Norhill Historic District

Design Guidelines Review
Public Hearing

Tuesday, March 24, 2026

2.3.c. Interior Lot Two-Story Rear Addition

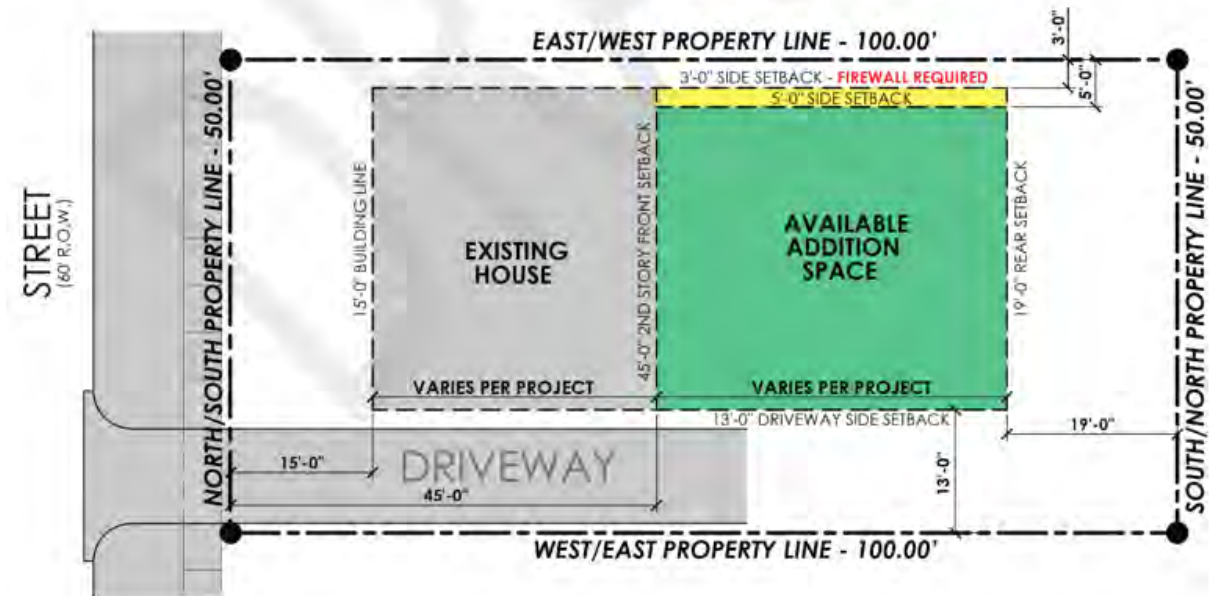
Suggestion, Limit the second floor setback to 45' from the front property line, with no other modifiers. Eliminate the provision allowing the rear setback to be offset when the front setback exceeds 15 feet.

We also deeply disagree with the restrictions that dictate the size of a second floor addition through the artificial constraints based on lot size and immaterial setback from rear. This undermines our ability or those of a future resident to add square footage to meet their family needs. (Not the first time this has been brought up in this process)

Specifically, the 19' rear setback which significantly restricts a second floor addition's square footage. As a home with an existing extension that is well within proposed rear setbacks, we are now limiting our add on capabilities. This would force us to add on to the back plus add a second floor just to get to the guidelines' max sq. footage. It appears to be an extremely arbitrary number without any explanation. Why 19'? It has zero impact on the impervious land usage and seems to be only "an opinion" of what the architects think looks better. Several homes would end up looking like one humped camel with this design. Our home certainly would. If you just do not want additions that go to the end of the first floor then have a three foot setback from the existing rear.

2.3.f. Corner Lot Two-Story Rear Addition

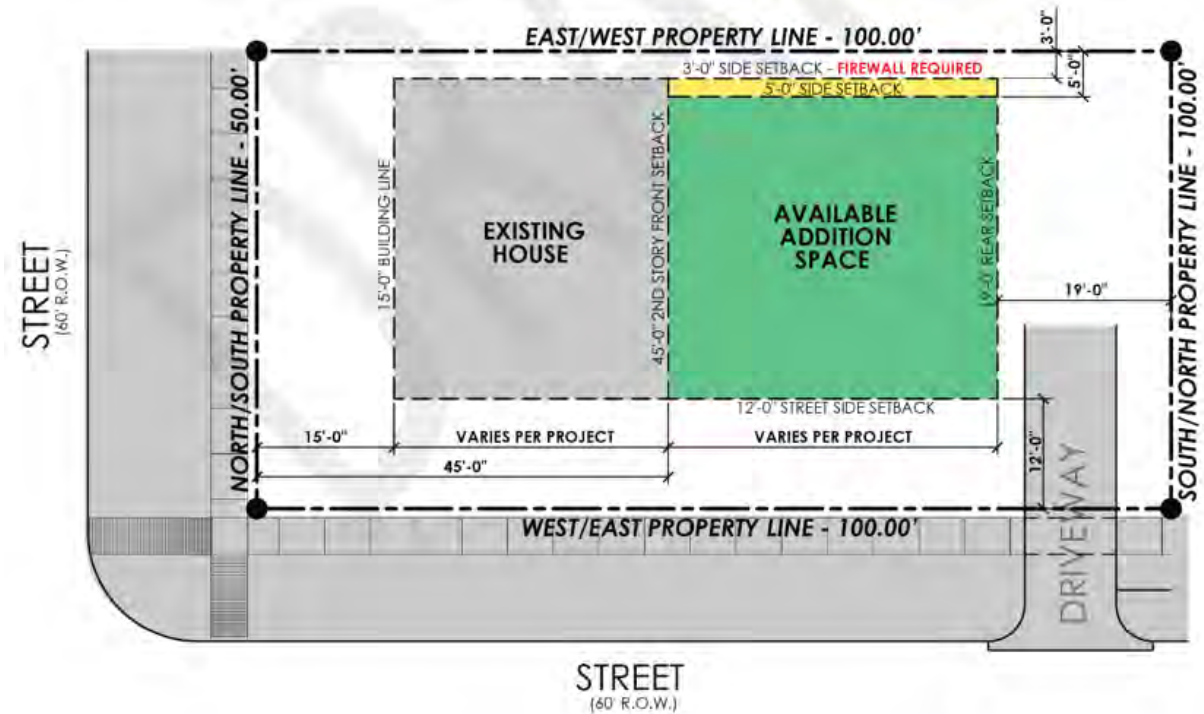
2.3.f. Corner Lot Two-Story Addition should similarly be modified.

2.3.g. Interior Lot Porte-Cochère, Carports, Auxiliary Buildings, and Garage Construction/Addition

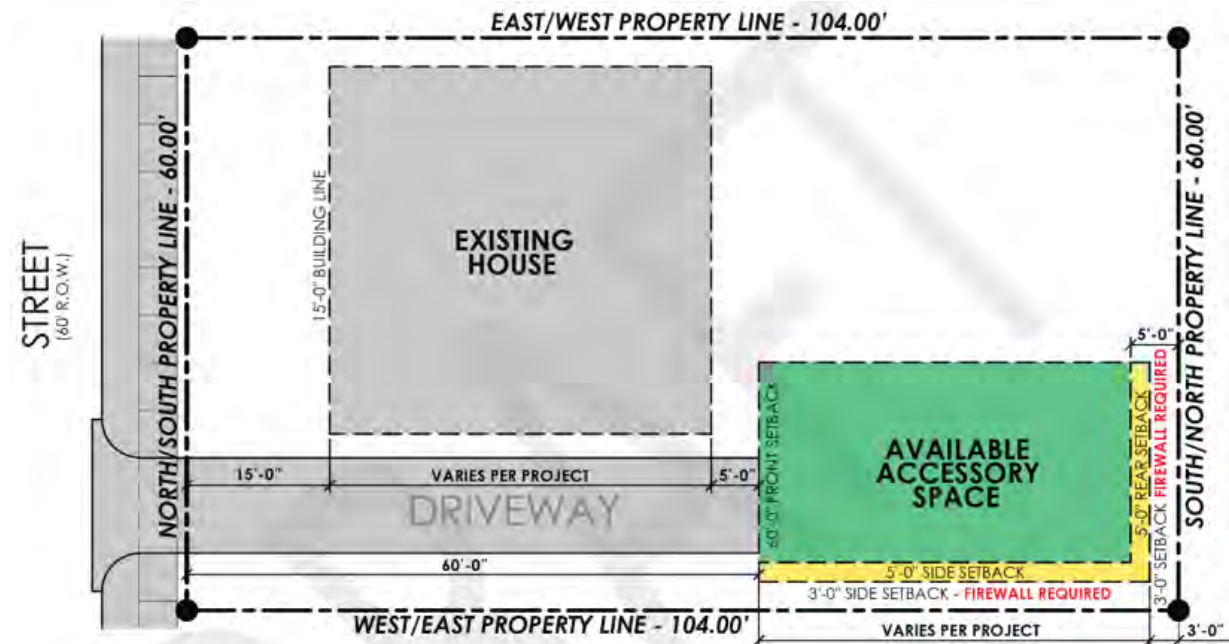
2.3.g: Both the City Draft and NNA Guidelines have a 5' minimum distance between the exterior walls of the garage and house. Based on plans reviewed and the limitations of space this should be reduced to a 3' clear space between siding face of a house and siding face of a garage.
